**COUNTY OF LOS ANGELES  
DEPARTMENT OF PUBLIC WORKS  
BUILDING AND SAFETY DIVISION**

**PUBLIC HOUSING  
PLAN REVIEW LIST**

**FIGURE 11B – 809.10.6.3**

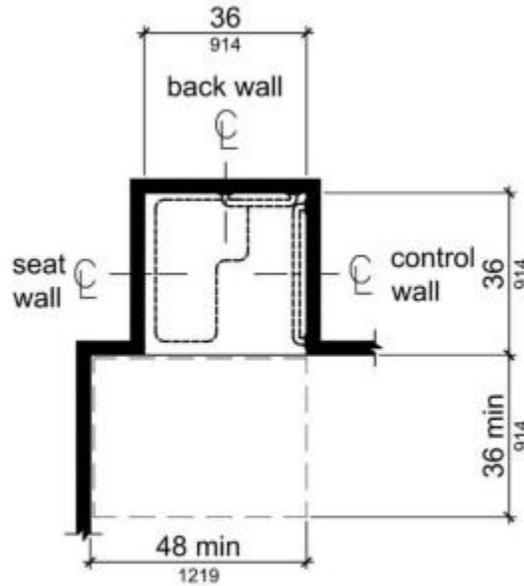
49. A clearance of 36 inches wide minimum by 48 inches long minimum measured from the control wall shall be provided outside shower as illustrated on Figure 11B-809.10.6.3. **§11B-809.10.6.3**
